Access Compliance Report

Public Rights-of-Way

(Curb Ramps)

Intersection ID: 6473	Main Street: MINERAL_SPRINGS_RD	Cross Street: N_GRAHAM_ST	Location:	N
ADA ID: 78D043E56057	Ramp Type: Perp	Initial Pass/Fail: Fail	Overall Compliance: No	Severity Score: 22.5
Codes/Mitigation Info/Possible Solution		Field Measurements/Component Compliance

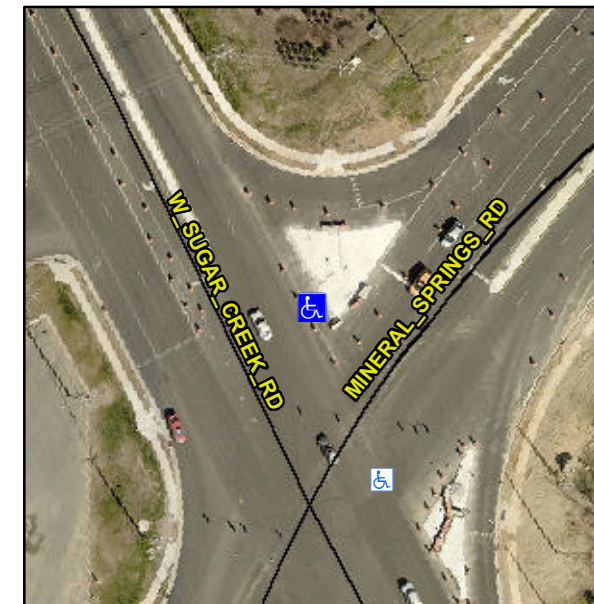
R304.5.1, R304.2.2, R304.5.3

Compliance	Description	Data	Compliance	Description	Data
N/A	Ramp Length (in)	61.0	No	Ramp Slope (%)	9.5
No	Ramp Width (in)	37.0	No	Ramp XSlope (%)	2.6
N/A	Flare Type LT	N/A	N/A	Flare Type RT	N/A
N/A	Flare Slope LT (%)	N/A	N/A	Flare Slope RT (%)	N/A
N/A	Flare Traversable LT?	N/A	N/A	Flare Traversable RT?	N/A
N/A	Landing Length (in)	N/A	N/A	DWS Provided?	N/A
N/A	Landing Width (in)	N/A	N/A	DWS Contrast?	N/A
N/A	Landing Slope (%)	N/A	N/A	DWS Length (in)	N/A
N/A	Landing X Slope (%)	N/A	N/A	DWS Full Width?	N/A
N/A	Landing Curb? (Y/N)	N/A	N/A	DWS Offset (in)	N/A
N/A	Shared Landing?	N/A			
N/A	Gutter Ponding?	N/A	N/A	Gutter Slope (%)	N/A
N/A	Gutter Lip Ht (in)	N/A	N/A	Gutter X Slope (%)	N/A
N/A	Painted X Walk1?	No	N/A	Painted X Walk2?	N/A
	X Walk 1 Direction	To S		X Walk 2 Direction	N/A
N/A	X Walk 1 Width (in)	N/A	N/A	X Walk 2 Width (in)	N/A
	X Walk 1 Slope (%)	2.3		X Walk 2 Slope (%)	N/A
	X Walk 1 X Slope (%)	0.7		X Walk 2 X Slope (%)	N/A

Remove & Replace Entire Ramp.
